Info Only: Comments from Service  
Engineering Engineering are in blue text.

Final Drainage Report

# Overlook at Homestead Filing No. 1 El Paso County, Colorado

***APPENDIX D: HYDRUALICS***

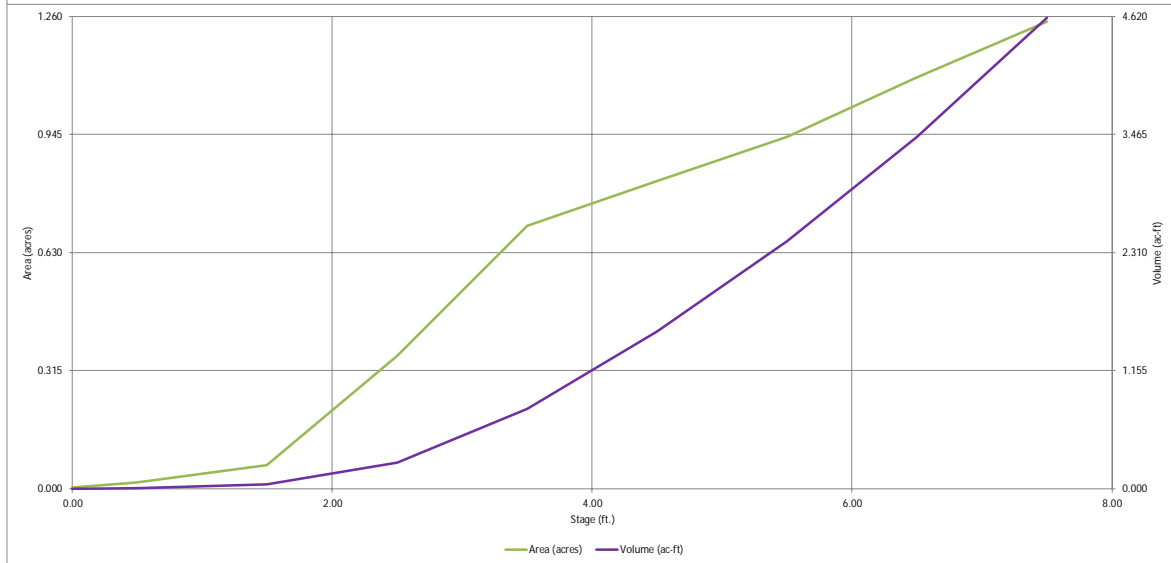
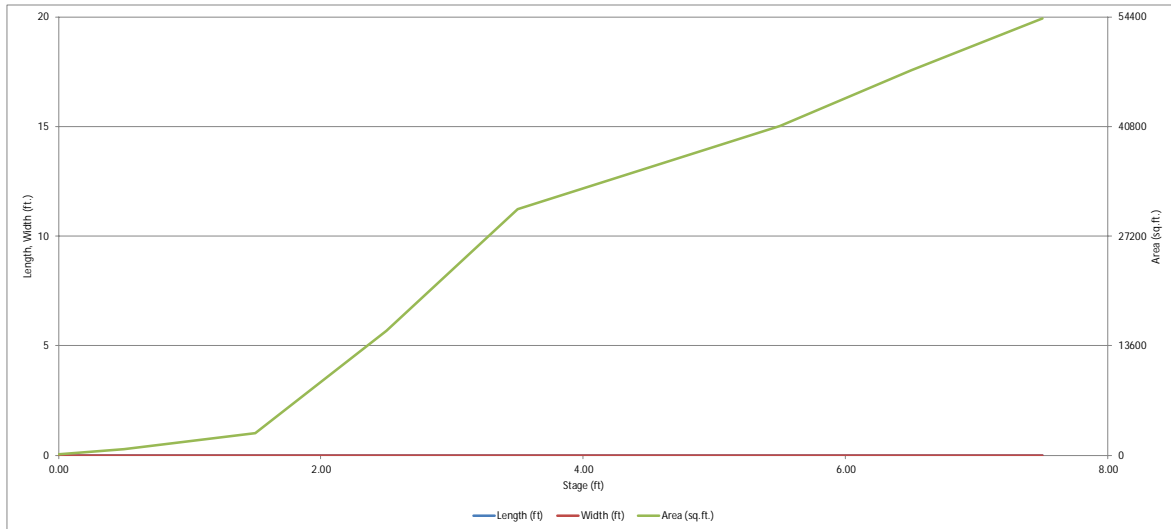
Add calculations for forebays, forebay notches, trickle channel.

Please provide forebay design calculations. The minimum forebay volumes are shown on MHFD T-5 Table EDB-4. The minimum forebay volume should be 1-3% of the undetained peak 100-year discharge, depending on the tributary impervious acreage. And the forebay outlet should release 2% of the undetained peak 100-year discharge

Per DCMv2 – Chap 4.2, trickle channel should at a minimum provide capacity equal to twice the release capacity at the upstream forebay outlet. Provide these calcs in the drainage report and revise plans as needed.

# DETENTION BASIN STAGE-STORAGE TABLE BUILDER

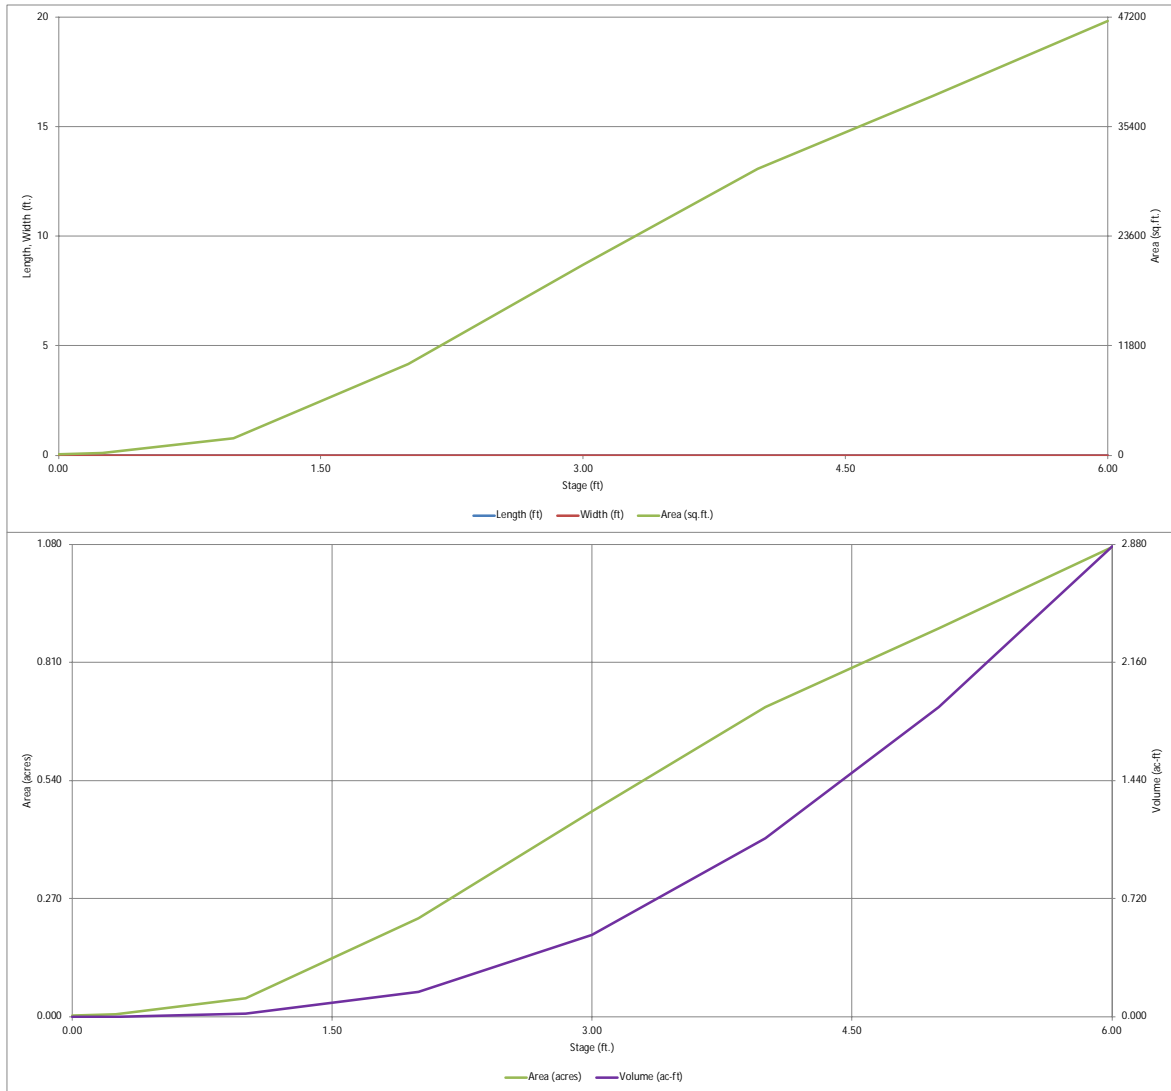
Fill out stage column

OVERLOOK FILING NO. 1  
 EL PASO COUNTY, COLORADO  
 CONSTRUCTION DOCUMENTS  
**PROPOSED DRAINAGE MAP**

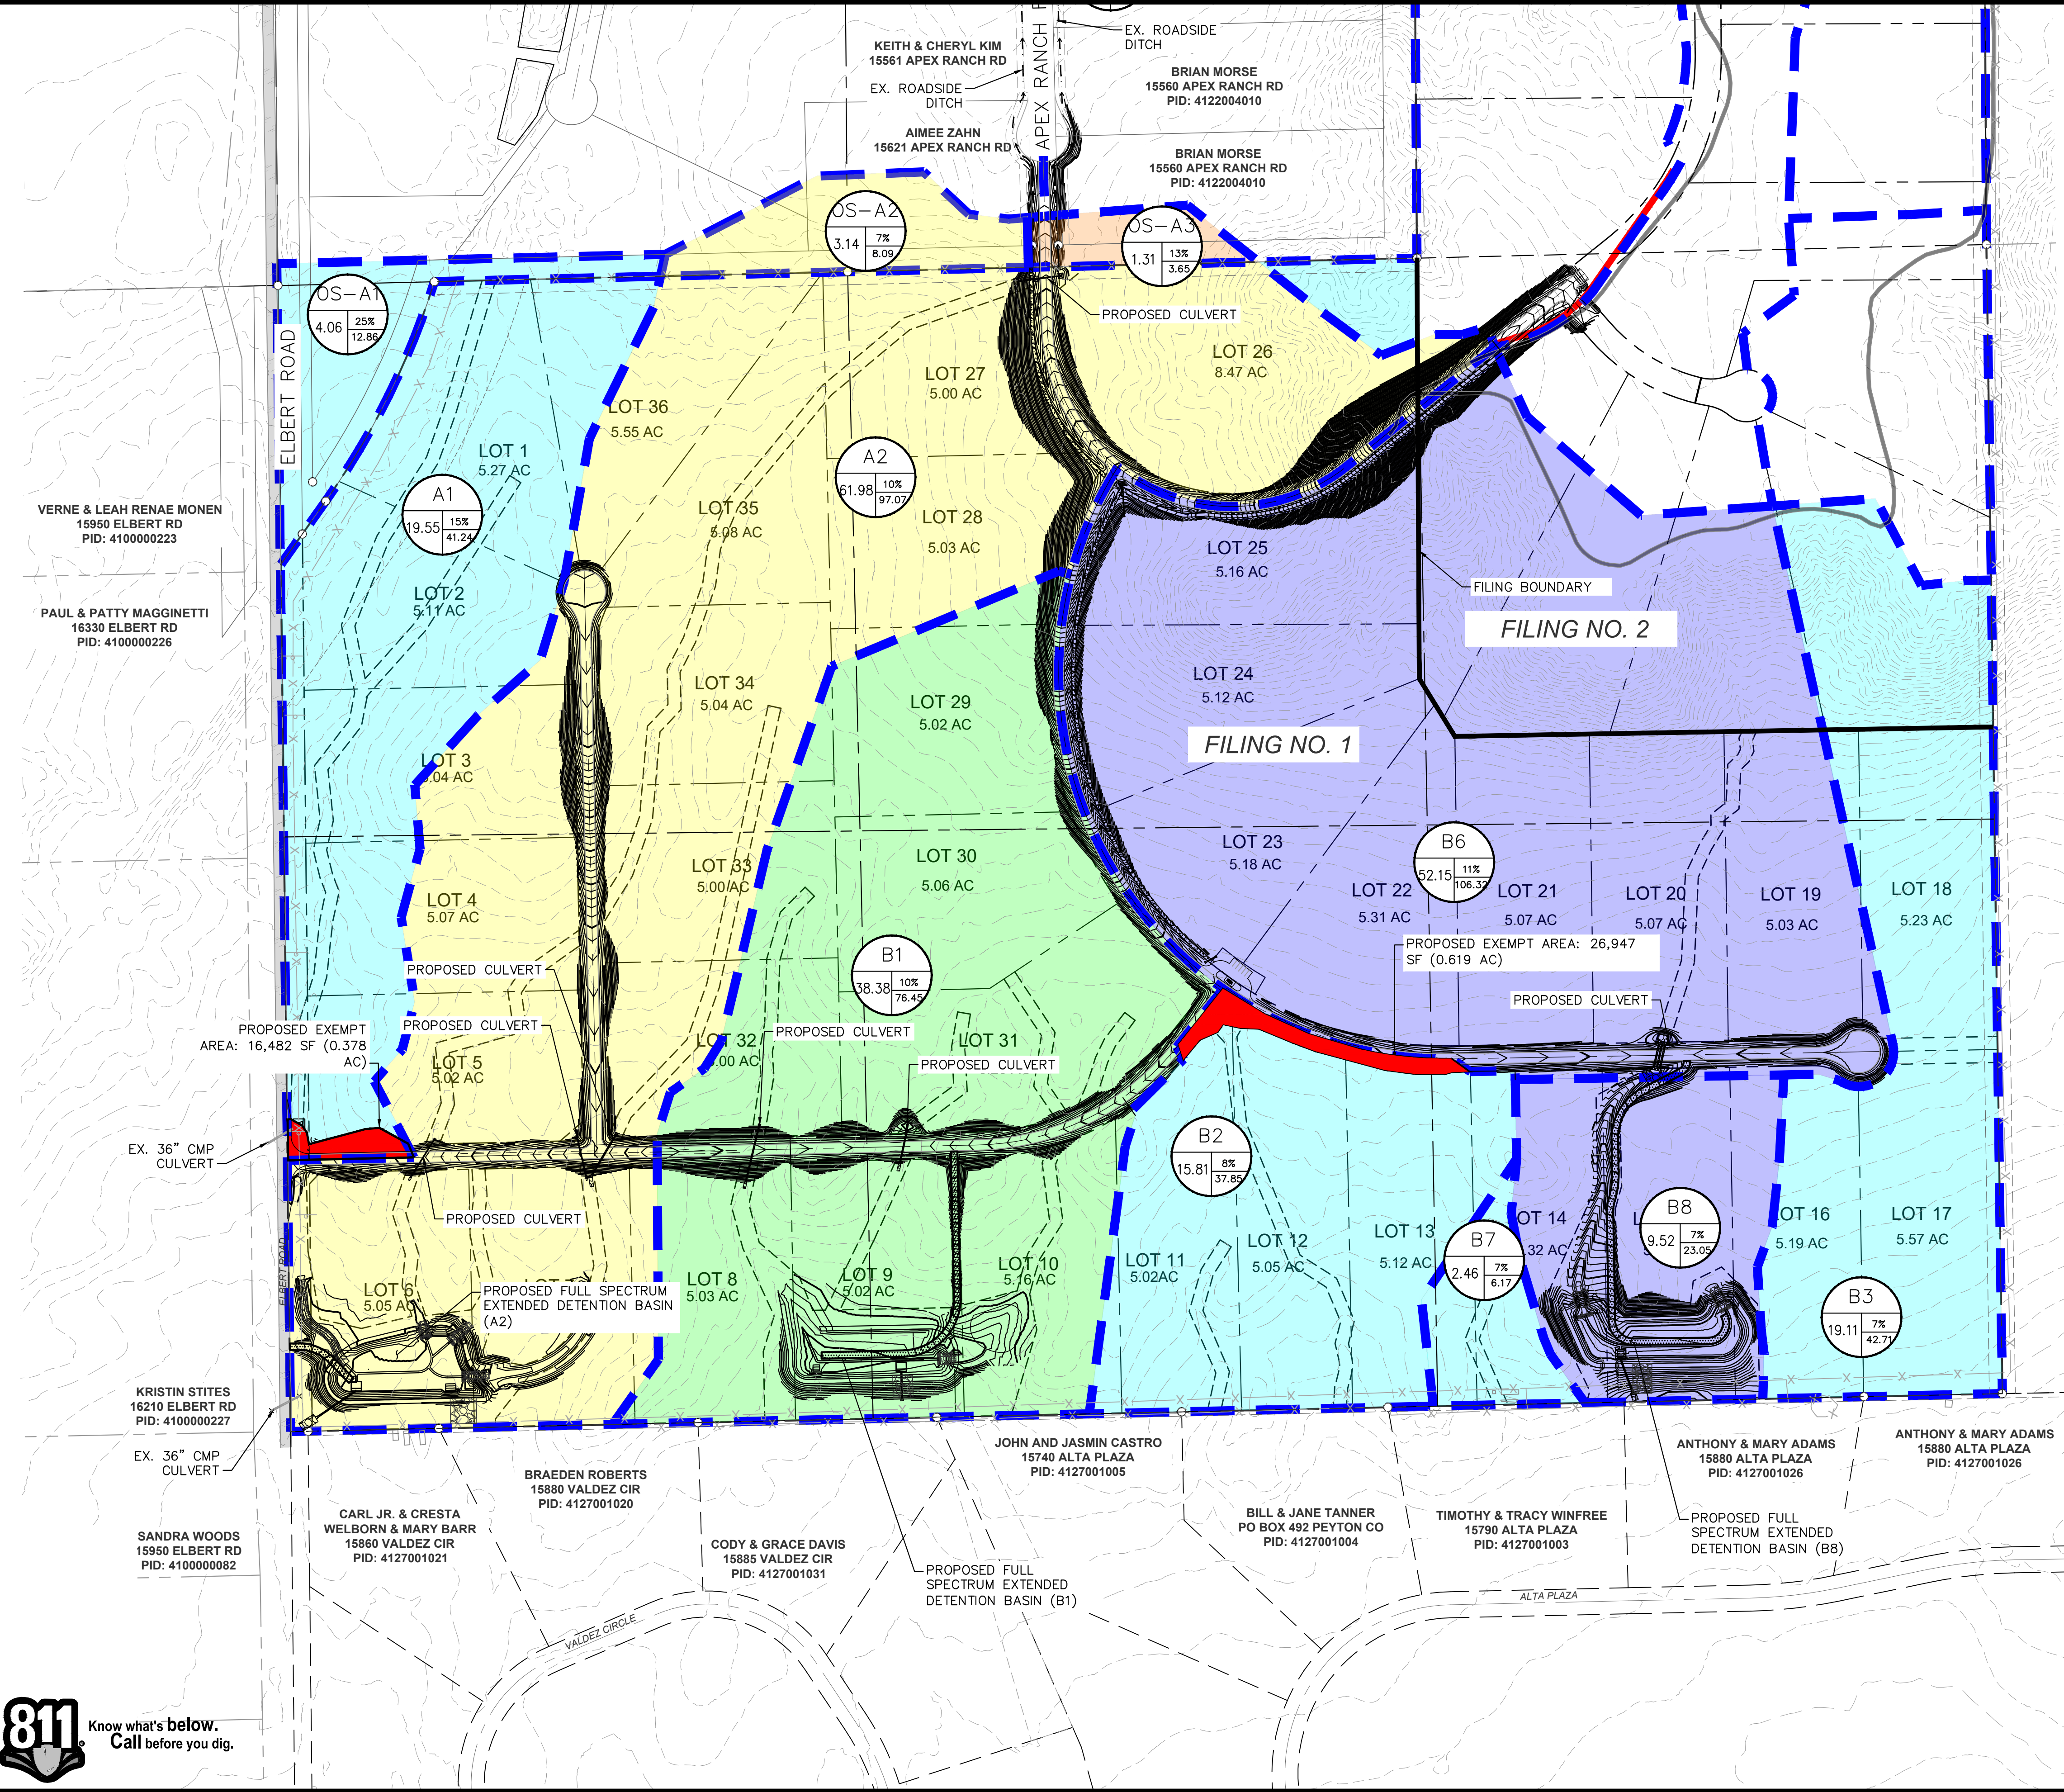
No longer TSB, please remove.

Per ECM Chapter 2, Section 2.6.9.G, parallel culverts are not allowed due to maintenance concerns. Please revise the design accordingly. If this condition cannot be met, please submit a deviation request to the County Engineer for consideration.
